GGG-B-191a
INTERIM AMENDMENT-2
September 16, 1964
SUPERSEDING
GGG-B-191a
INTERIM AMENDMENT-1
November 18, 1963

INTERIM AMENDMENT

FEDERAL SPECIFICATION

BENDER, TUBE, HAND (PORTABLE)

Figure 1. - Type I, class 1, tube bender, worm-gear actuated, multiple size, small radius bending.

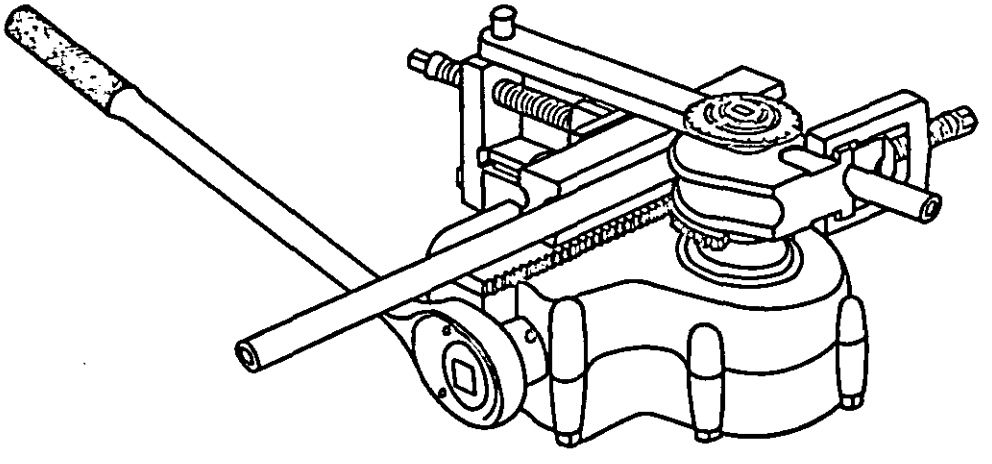
Page 3, after Table I: Add the following as a new Figure 1:

"3.12.8 Class 1, small radius bending.- Class 1 tube benders shall be furnished with all necessary parts for bending all nominal sizes of the tubing specified in table I. They shall conform to table I and shall be similar to figure 1".
